591, 593 COBBITTY ROAD &
1 FRESHWATER DRIVE, COBBITTY
(PRECINCT 2A STAGE 1 &
TRANCHE 5a STAGE 1)
ROAD & DRAINAGE DESIGN

ISSUED FOR SUBDIVISION WORKS CERTIFICATE

WORKS AS EXECUTED
WORKS AS EXECUTED INFORMATION SHOWN IN RED.
DATE: 15/09/2025

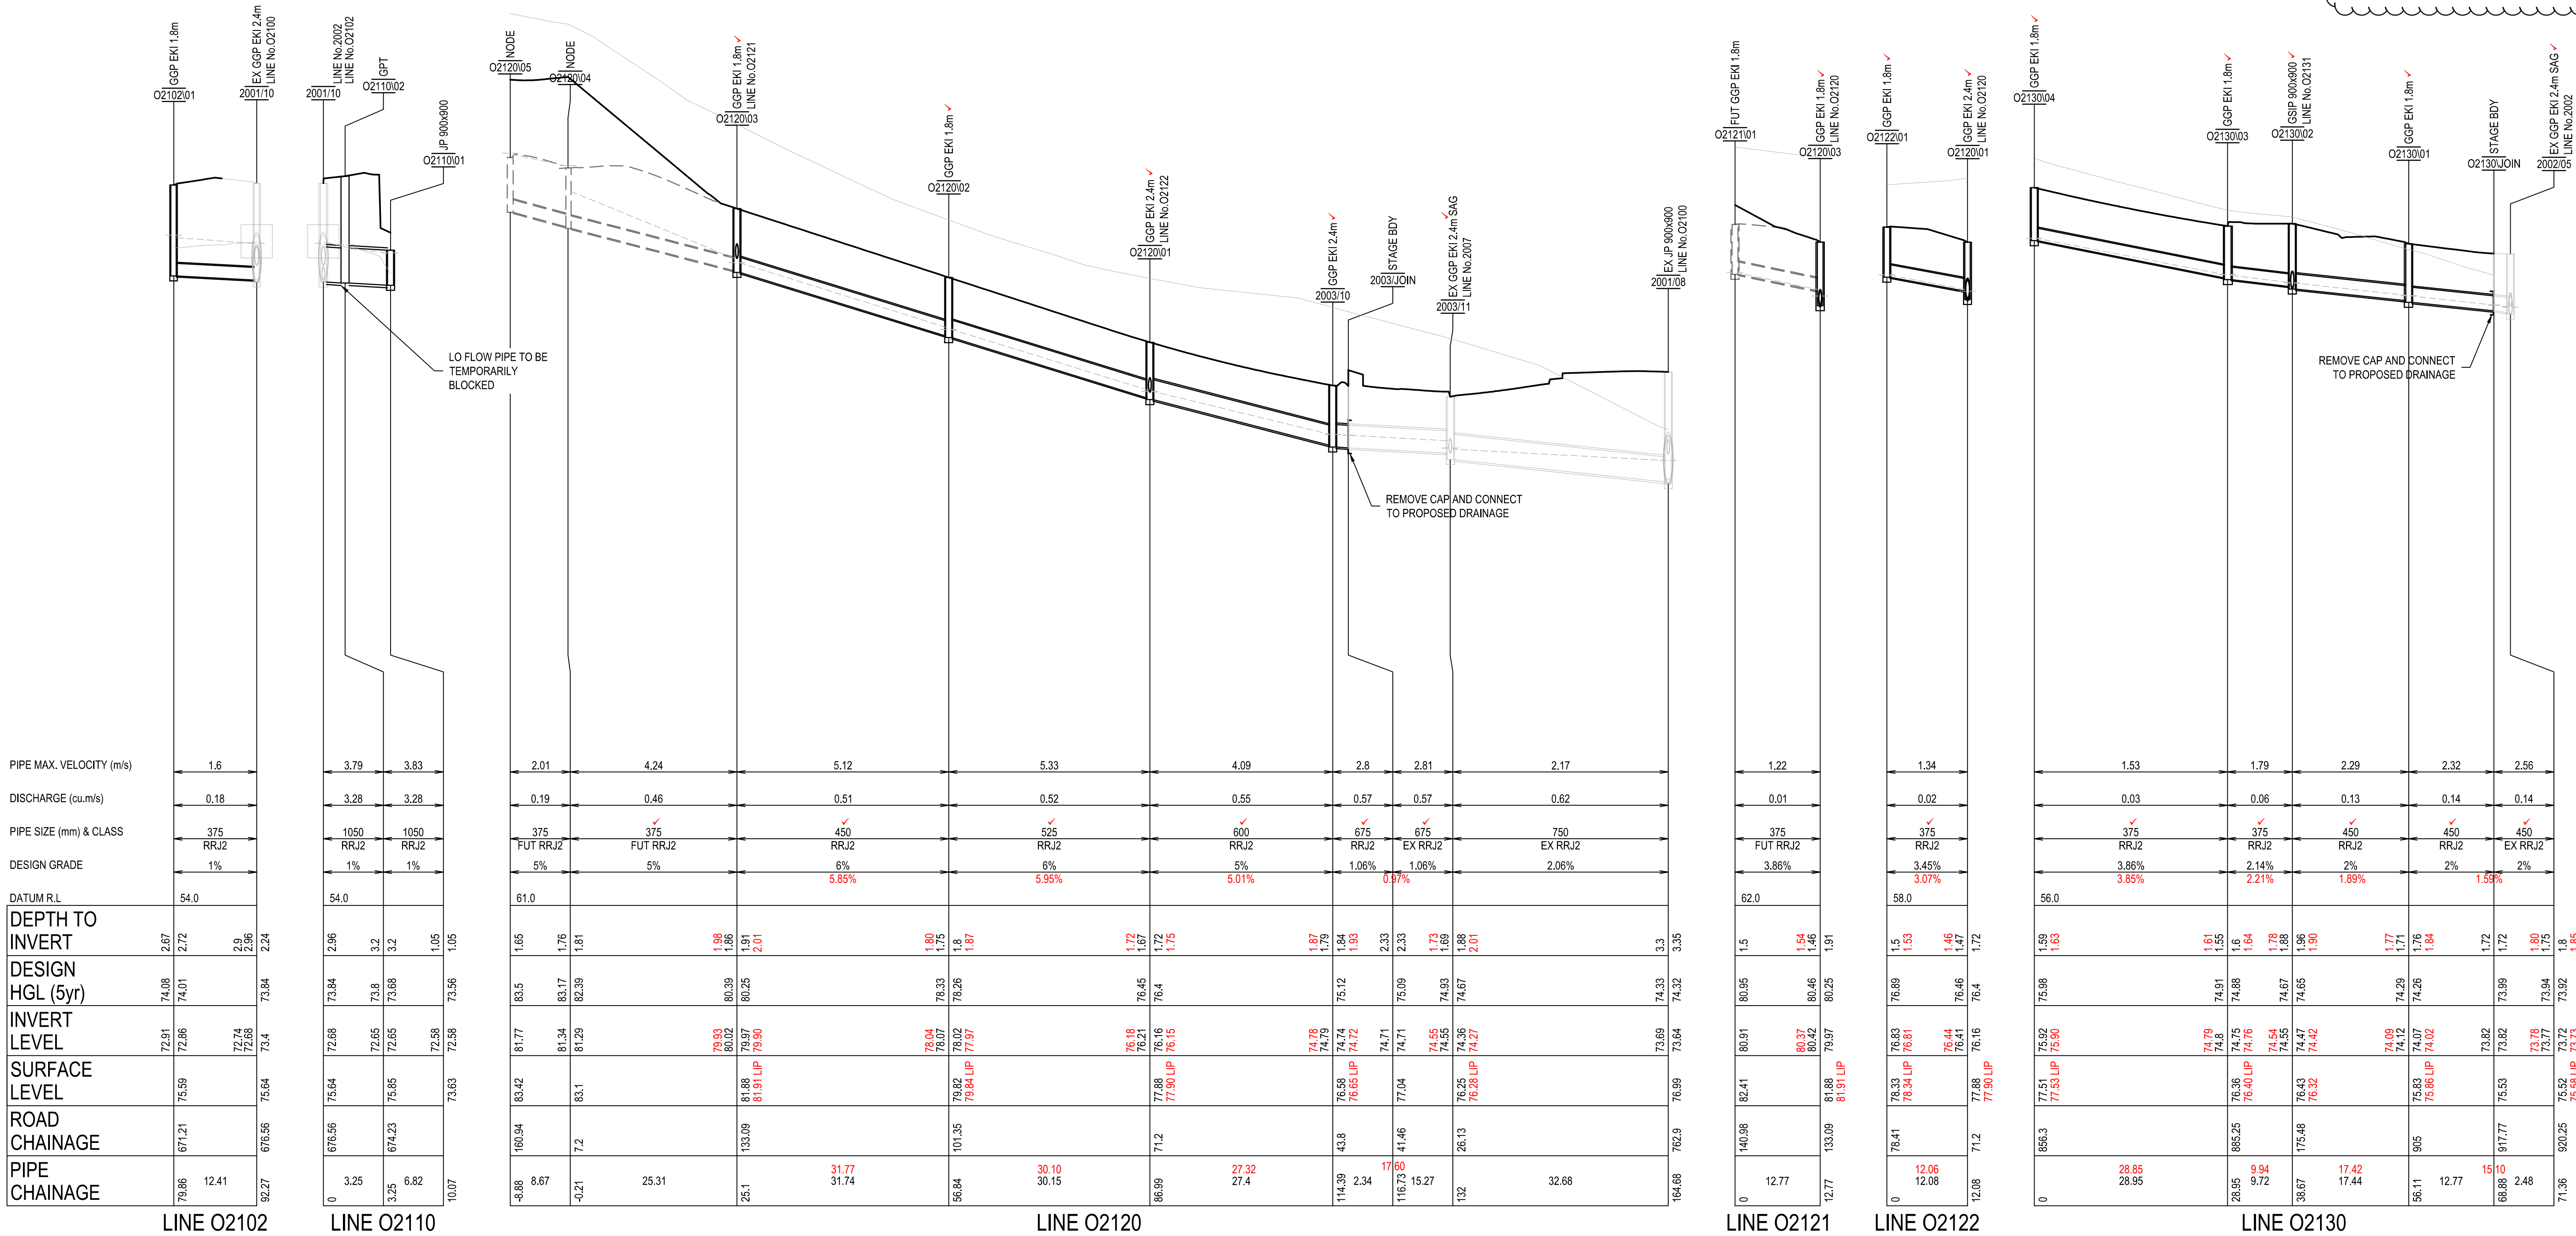
*PIPE O2000 UPSIZED
*PIT NUMBERS AMENDED
*HGL LOWERED

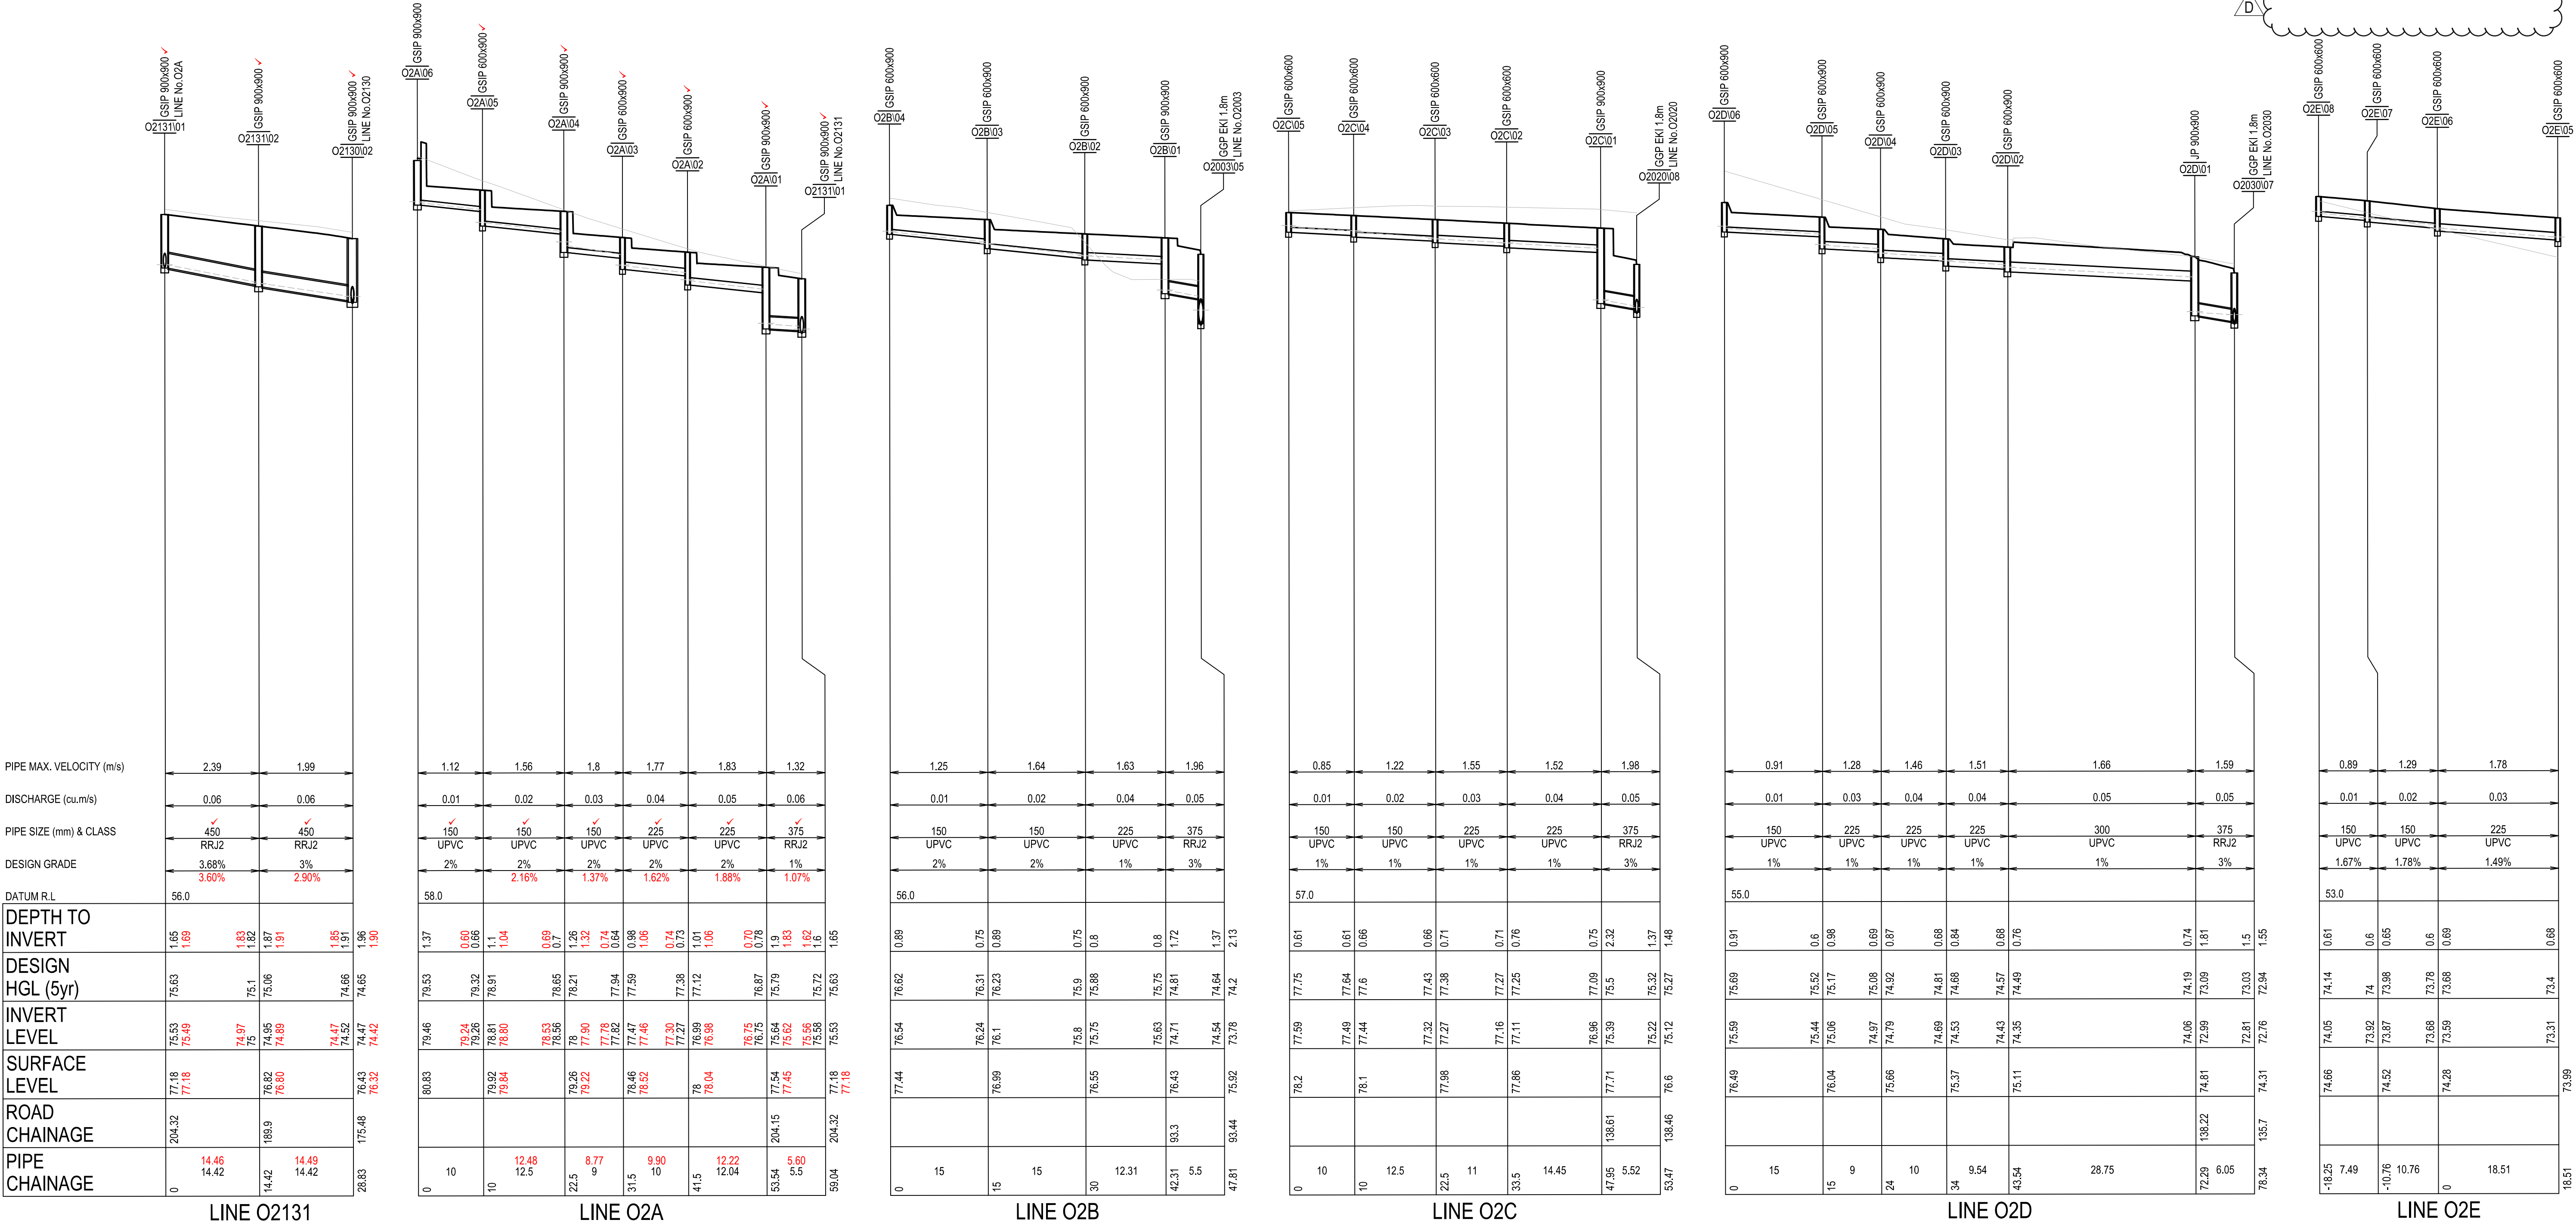
*PIPE O2000 UPSIZED
*PIT NUMBERS AMENDED
*HGL LOWERED
